SUNDRY NOTICES AND REPORTS ON WELLS (DO NOT USE THIS FORM FOR PROPOSALS TO DRILL OR TO DEEPEN OR PLUG BACK TO A DIFFERENT RESERVOIR. USE "APPLICATION FOR PERMIT" (FORM C-101) FOR SUCH PROPOSALS.) 1. Type of Well: Oil Well <input type="checkbox"/> Gas Well <input checked="" type="checkbox"/> Other		WELL API NO. 30-005-61146

4. Well Location Unit Letter <u>N</u> : <u>660</u> feet from the <u>South</u> line and <u>1730</u> feet from the <u>West</u> line Section <u>30</u> Township <u>8S</u> Range <u>26E</u> NMPM Chaves County		7. Lease Name or Unit Agreement Name Acme Com

CONDITIONS OF APPROVAL FOR PLUGGING & ABANDONMENT

Well Name & Number: Acme Com #4

WELL NAME: ACME Com #4 FIELD: Pecos Slope Abo

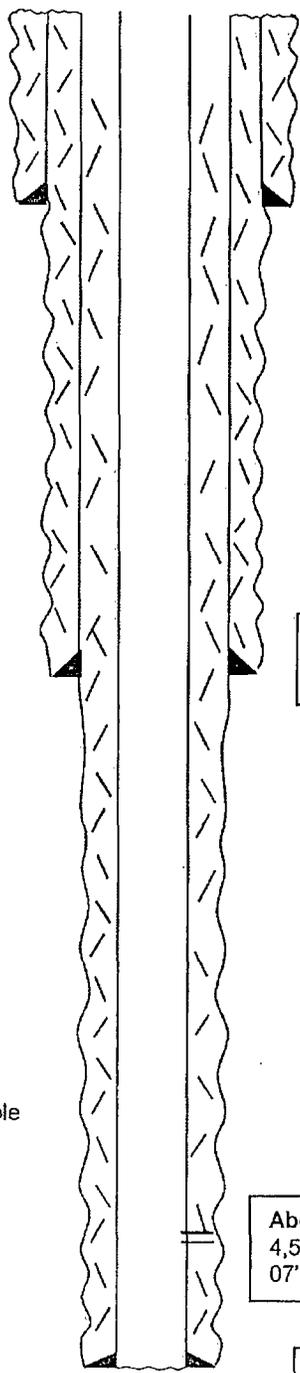
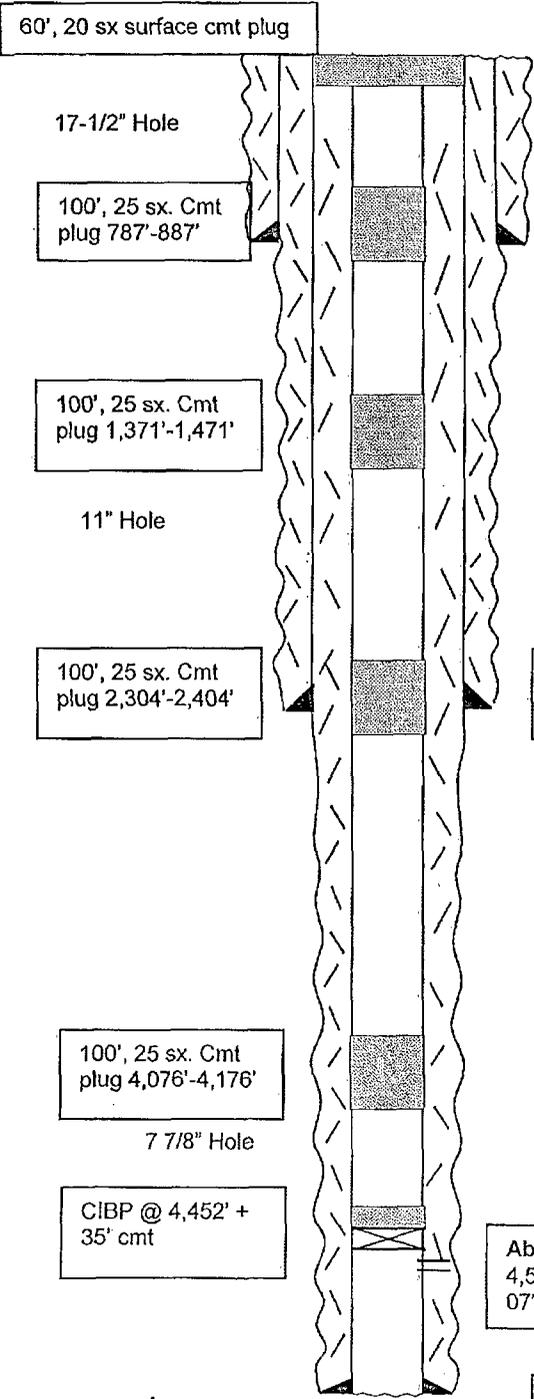
- MIRU WSU. Rig up safety equipment as needed. No casing recovery will be attempted. TOH with 2-7/8" tubing.
- TIH and set a CIBP at 4,452' and cap with 35' cement. This puts a plug over the open Abo perforations.
- Spot a 25 sx Class "C" cement plug from 4,076'-4,176'. This puts a 100' plug across the top of the Abo.
- Spot a 25 sx Class "C" cement plug from 2,304'-2,404'. POOH. This puts a 100' plug across the Intermediate Casing shoe. WOC and tag plug.
- Spot a 25 sx Class "C" cement plug from 1,371'-1,471'. This puts a 100' plug across the top of the Glorietta.
- Spot a 25 sx Class "C" cement plug from 787'-887'. This puts a 100' plug across the Surface Casing shoe. WOC and tag plug.
- Perforate and spot a 20 sx Class "C" cement plug from 60' up to the surface outside and inside casing.
- Remove all surface equipment, weld dry hole marker and clean location as per regulations.

7. Every attempt must be made to clean the well bore out to below the perms, before any plugs can be set, by whatever means possible.
8. **Cement Retainers may not be used.**

9. Squeeze pressures are not to exceed 500 PSI, unless approval is given by NMOCD.
10. Plugs may be combined after consulting with and getting approval from NMOCD.
11. Minimum WOC time for tag plugs will be 4 Hrs.
